RE: **PETITION NO. 1593** – The Connecticut Light and Power Company d/b/a Eversource Energy Declaratory Ruling for the Montville Substation to North of Kitemaug Road Rebuild Project consisting of the replacement and reconductoring of electric transmission line structures along approximately 1.1 miles of its existing electric transmission line right-of-way shared by its existing 115-kilovolt (kV) 1090 and 1000 Lines between Montville Substation and approximately 1200 feet north of Kitemaug Road in Montville, Connecticut, and related electric transmission line and substation improvements. **Request for Project Change.**

Request for minor project change.

Additional Matted Area (Refer to Map Sheet 2 of 3, revised 2/27/2024):

Map Sheet 2 of 3

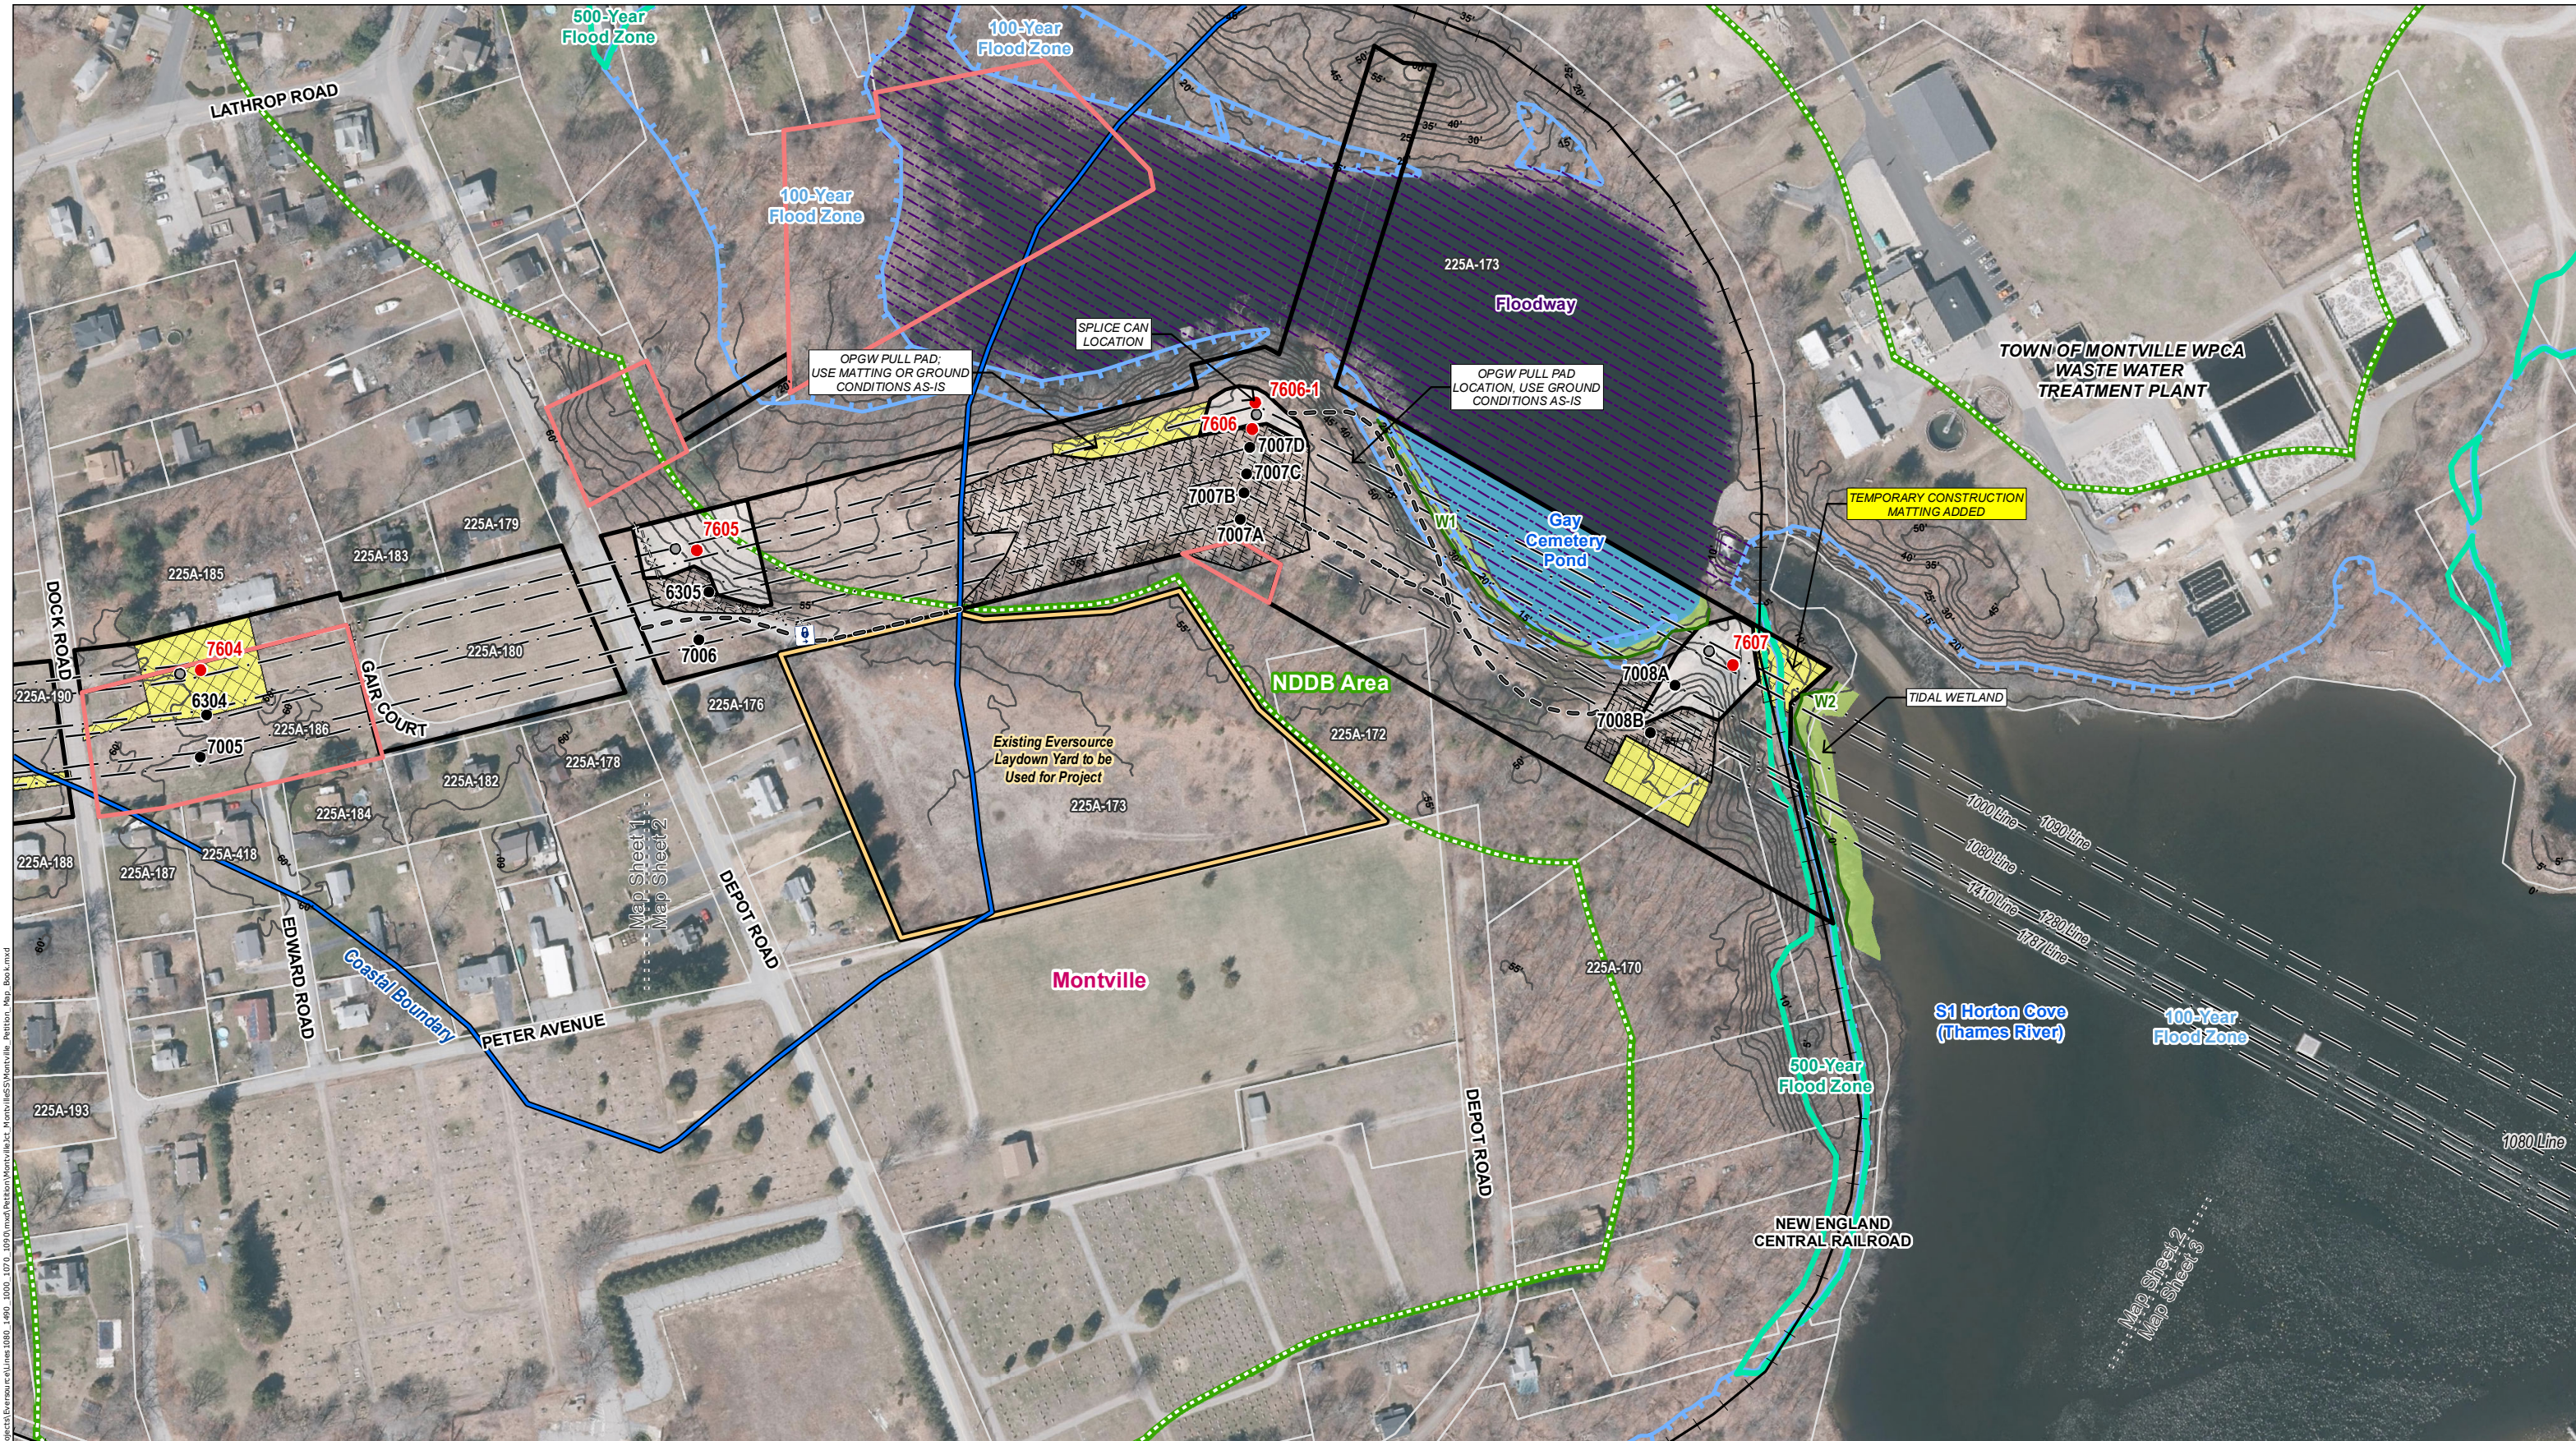
Due to difficult terrain near proposed structure 7607, it was determined that approximately 5,352 square feet of additional matted workspace is needed over an abandoned and non-operational railroad to the north of an existing stone work pad within the right-of-way to accommodate the size of the crane needed to set the new structure. The new matting will be within a FEMA 100 & FEMA 500 Flood Zone but outside an adjacent tidal wetland. Project Management will monitor weather forecasts and remove matting if a large flooding event is anticipated.

NO.	DATE	REVISIONS
1	2/27/24	Temporary Construction Matting added to Str 7607 work area

Pursuant to Condition No. 1 of the Council's January 5, 2024, Declaratory Ruling, the request to install additional temporary matting north of Structure 7607 is hereby approved.
